ADDRESS: 801 EDISON**APPLICATION NO: HDC2025-00037****HISTORIC DISTRICT: BOSTON-EDISON****APPLICANT/CONTRACTOR: BRENDAN MCGLINCH/MCGLINCH AND SONS****OWNER: AMANDA CONNOLLY & MICHAEL GIBB****DATE OF STAFF SITE VISIT: 2/25/2025****DATE OF PROVISIONALLY COMPLETE APPLICATION: 02/18/2025****SCOPE: REPLACE WINDOWS, GUTTERS, AND DOWNSPOUTS****EXISTING CONDITIONS**

801 Edison, designation photo taken in 1974

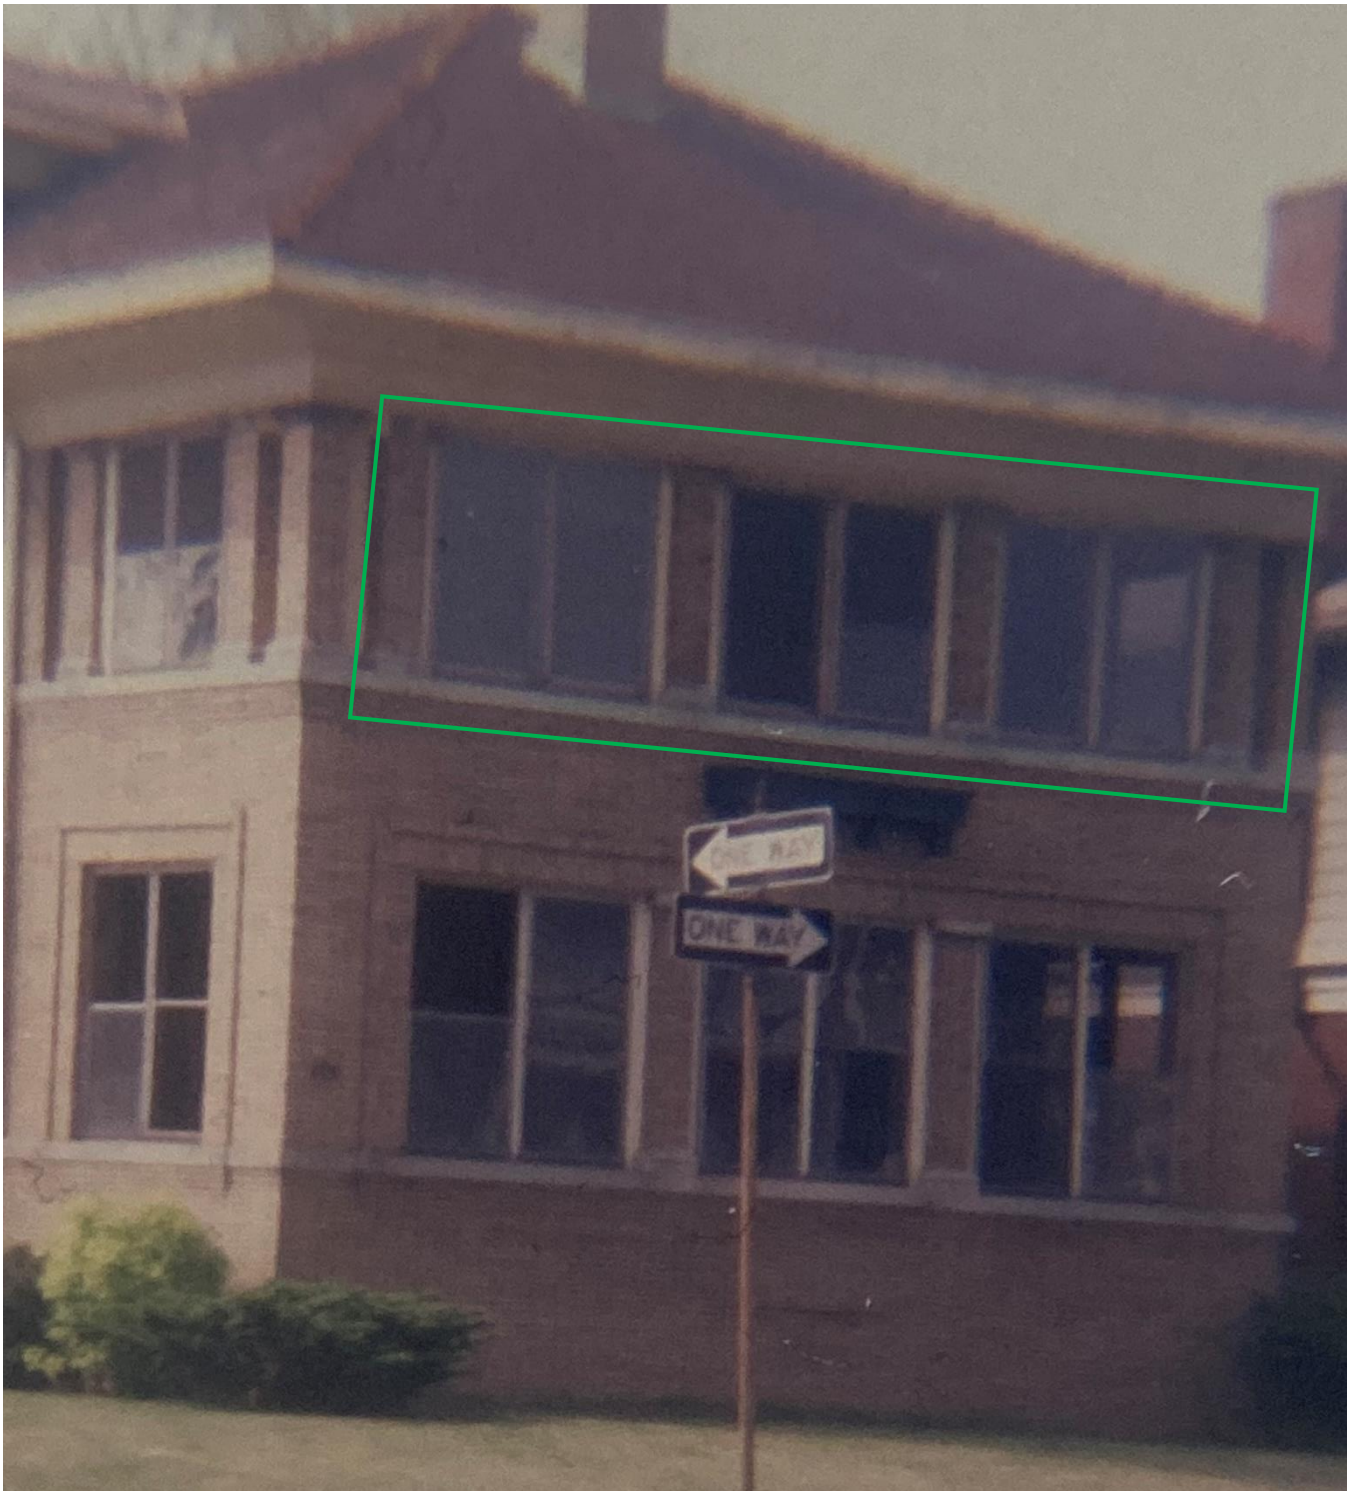
- The Boston-Edison historic district was designated in 1974
- See the below photos of the house which date from 1974 and 1980. Note that at the time of the district's designation, the house had a clay tile roof, and the porch windows appeared to be 1/1 storm windows and jalousie windows

- It is staff's opinion that the windows that were present at the side porch at the time of the district's designation were not original to the property's date of construction. Specifically, the porch was likely open when the house was built, and the jalousie and storm windows were likely installed post 1950s. Also, in 1974, the storm windows at the side porch appeared to be in poor condition. It is therefore staff's opinion that the windows present at the porch in 1974, at the time of the district's designation, were not distinctive character-defining elements of the house.

East/front façade, showing windows at porch which are proposed for replacement. Staff photo taken on 2/25/2025

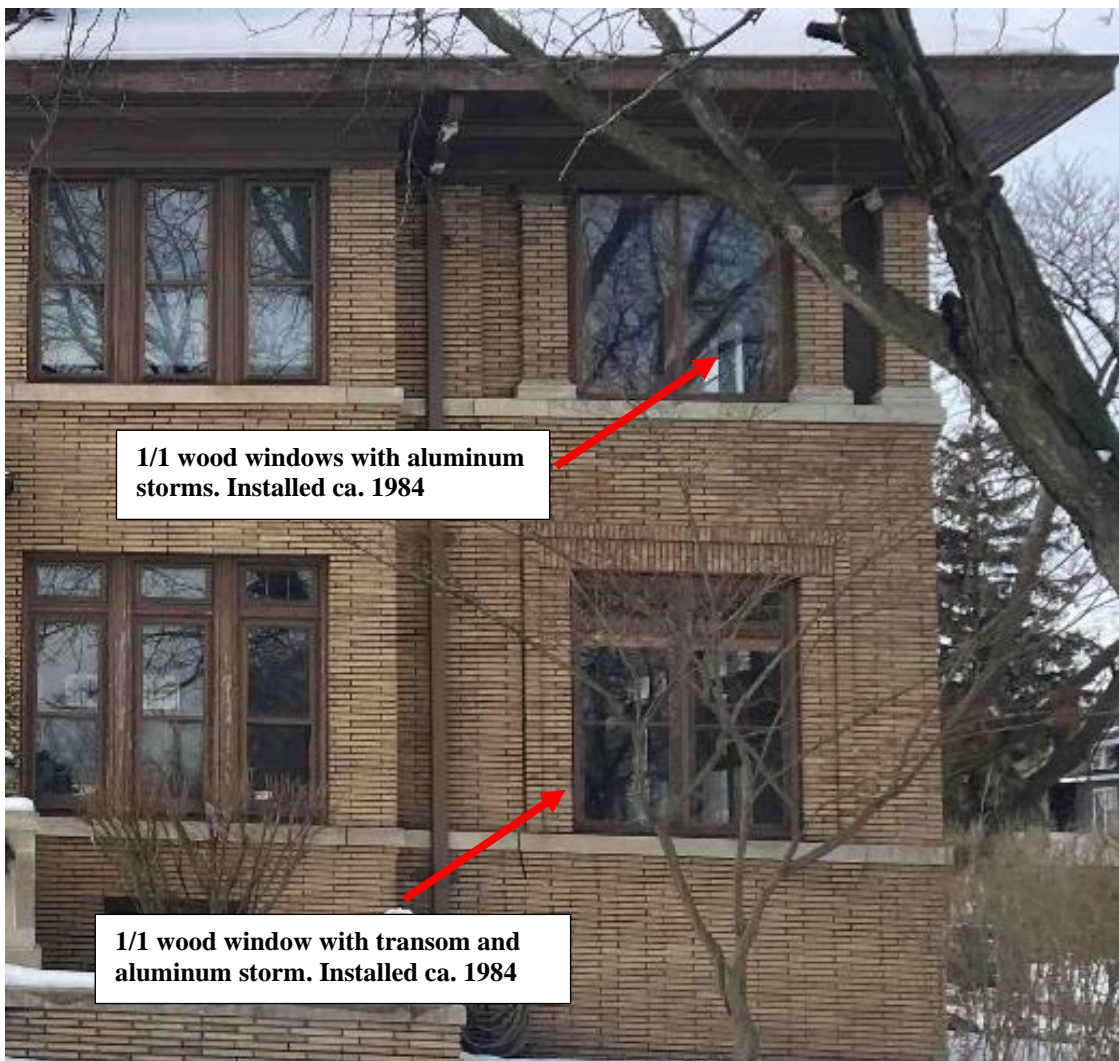
- See the below photos of the windows at the side two-story porch. A review of HDC records indicated that the current porch windows were likely installed in 1984. Note that the windows at the first story are 1/1 wood units and jalousie units. Each window at the first story is topped with a fixed transom with metal casing, consistent with the original wood windows at the house's main body, first floor. The porch's second story windows are 1/1 wood units and jalousie windows without transoms, which is consistent with the original wood windows at the house's main body, second floor. Aluminum storm windows, also added ca. 1984, are present at all of the porch windows with the exception of two jalousie windows at the porch's south façade, second story. Staff was unable to locate a COA for the existing wood porch windows. However, as noted above, the porch windows which were present in 1974/at the time of the district's designation which were replaced by the current windows were not original to the building's construction and were not character defining. Their removal in 1984 was therefore appropriate. However, staff would have recommended that any new windows proposed for installation at the side porch be simple 1/1 wood units with minimal casing/trim of a simple profile and clear/transparent, non-reflective glass as the openings at the porch would have originally been open/unenclosed. Staff therefore would have recommended against any proposal that the new windows include a transom.

- Staff supports the proposed removal of the existing porch windows as they are not historic-age, distinctive character defining features of the house.

North/side façade, showing windows at porch which are proposed for replacement. Staff photo taken on 2/25/2025

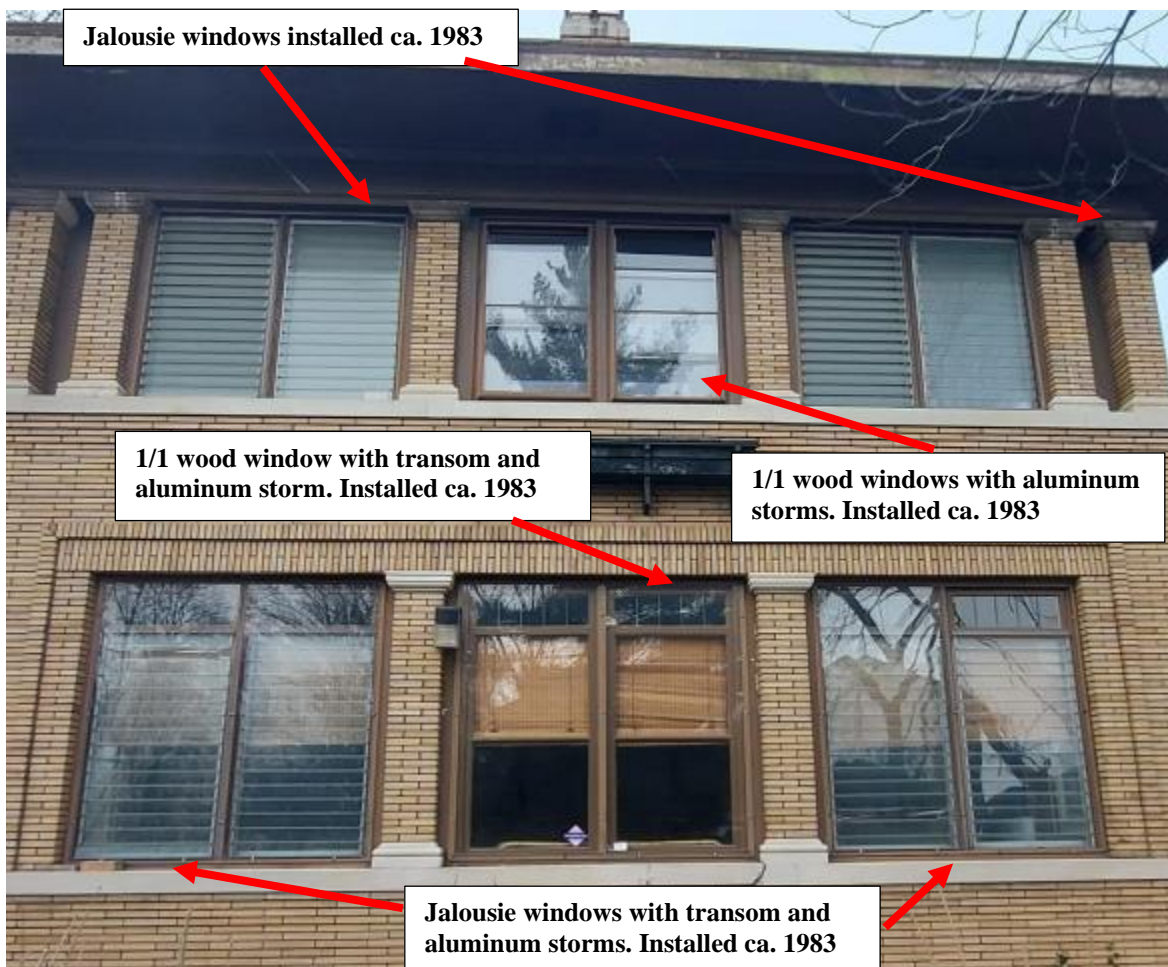
- Staff is generally in favor of the proposed new window product as the windows are aluminum-clad wood, double-hung units which are compatible with the existing historic windows. The casing/trim will provide a minimal profile, and the glazing will be clear/transparent/non-reflective, which would align with the porch's original open, unenclosed character. Also, the installation of the new windows will allow for the removal of the current aluminum storm windows at the porch, which would further minimize the appearance of the fenestration within the porch's openings. However, staff does have the following issues with the proposed product:

- The windows will have black screens which, when combined with the proposed black frames, will detract from the porch's original open character. Staff recommends that a less opaque screen be selected for this application

- The windows which include transoms will detract from the porch's original open character. Staff recommends that all of the windows have a simple 1/1 light configuration.

- The new porch windows shall not have black screens. A less opaque screen type/color shall be selected and submitted to staff for review and approval
- The new porch windows shall not include transoms. Rather, they shall have a simple 1/1 light configuration
- The windows at both the house's main body and two-story porch shall be one uniform color. Therefore:
 - The new porch windows shall be finished with brown color to match the color of the windows and storms at the house's main body
